Appendix 3

Approach to EIA

A3.3 CONSULTEE COMMUNICATIONS

Graphic sent by Malcolm Spaven 4th November 2021

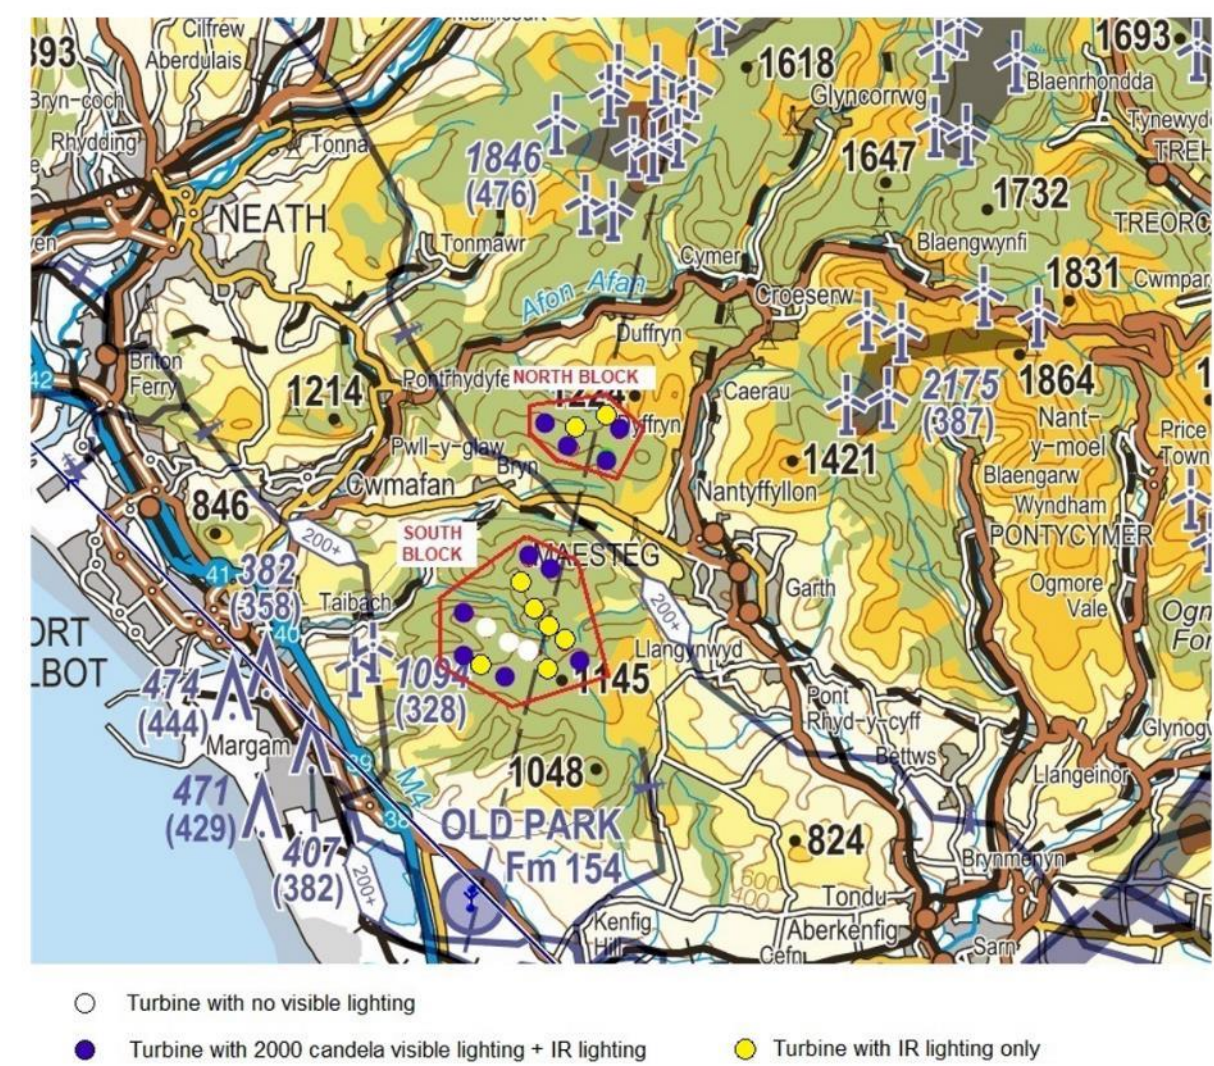
>Subject: RE: CAUTION: External email - Re: Wind farm consultation: Y
>Bryn, South Wales (UNCLASSIFIED)
>
>Dear Tulki
>
>Many thanks for your email in August and my apologies for the delay
>in responding.
>
>I have attached an annotated version of your suggested lighting
>configuration. This identifies the turbines that we would propose
>to put IR lights on as well as those with visible spectrum
>lighting. As you'll see, there are three turbines in the southern
>block that we would propose not to have any form of lighting since
>they are not on the perimeter of the wind farm.
>
>I would welcome an opportunity to discuss our proposals with
>you. Could we set up a date and time for a call?
>
>Thanks and regards
>
>Malcolm Spaven
>
>
>At 16:51 03/08/2021, Jenkins, Tulki wrote:
>>Classification:UNCLASSIFIED
>>
>>Malcolm,
>>
>>Please find attached drawing. I have marked in blue the lights we would
>>like to meet the standard aviation lighting requirements. In white I

>>have marked towers we would be happy for lower intensity lighting to be
>>used.
>>
>>This layout means that from all potential routings across the site the
>>aircrew should be able to identify a minimum of three lights to allow
>>them to draw a mental triangle of area to avoid. There is a few more
>>lights requested in between the two blocks due to our potential
>>requirement to fly between the two blocks.
>>
>>Best Wishes
>>
>>Tulki
>>
>>
>>
>>Tulki Jenkins | Helicopter Landing Site Surveyor UK Aviation |
>>Aviation Babcock International Group Babcock Onshore | Building Se32-33
>>| Gloucestershire Airport | Cheltenham | Gloucestershire | GL51 6SP
>>Tel: +[REDACTED] | Alt Mob:
>>+[REDACTED] | mailto:[REDACTED]
>>www.babcockinternational.com
>>
>>-----Original Message-----
>>From: Malcolm Spaven <[REDACTED]>
>>Sent: 03 August 2021 14:06
>>To: Grenfell, James <[REDACTED]>
